Access Compliance Report

Public Rights-of-Way

Intersection ID: 8515	Main Street: ATANDO_AV	Cross Street: STATESVILLE_AV	Location: SE
ADA ID: 97FD20B6C907	Ramp Type: Perp	Initial Pass/Fail: Fail	Overall Compliance: No
		Severity Score: 22.5

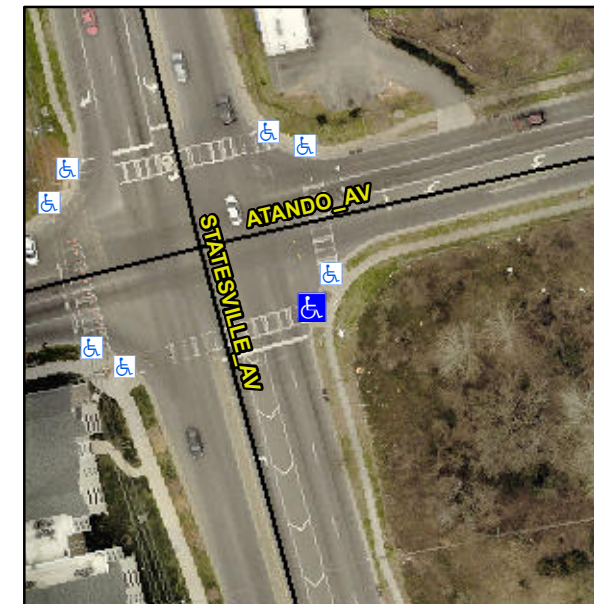
Not Found, R304.5.1, R304.2.2

Compliance	Description	Data	Compliance	Description	Data
N/A	Ramp Length (in)	60.0	No	Ramp Slope (%)	10.1
No	Ramp Width (in)	42.0	Yes	Ramp XSlope (%)	2.7
N/A	Flare Type LT	N/A	N/A	Flare Type RT	N/A
N/A	Flare Slope LT (%)	N/A	N/A	Flare Slope RT (%)	N/A
N/A	Flare Traversable LT?	N/A	N/A	Flare Traversable RT?	N/A
N/A	Landing Length (in)	N/A	N/A	DWS Provided?	N/A
N/A	Landing Width (in)	N/A	N/A	DWS Contrast?	N/A
N/A	Landing Slope (%)	N/A	N/A	DWS Length (in)	N/A
N/A	Landing X Slope (%)	N/A	N/A	DWS Full Width?	N/A
N/A	Landing Curb? (Y/N)	N/A	N/A	DWS Offset (in)	N/A
N/A	Shared Landing?	N/A			
N/A	Gutter Ponding?	N/A	N/A	Gutter Slope (%)	N/A
N/A	Gutter Lip Ht (in)	N/A	N/A	Gutter X Slope (%)	N/A
N/A	Painted X Walk1?	Yes	N/A	Painted X Walk2?	N/A
	X Walk 1 Direction	To W		X Walk 2 Direction	N/A
N/A	X Walk 1 Width (in)	102.0	N/A	X Walk 2 Width (in)	N/A
	X Walk 1 Slope (%)	0.2		X Walk 2 Slope (%)	N/A
	X Walk 1 X Slope (%)	4.3		X Walk 2 X Slope (%)	N/A

Remove & Replace Entire Ramp.
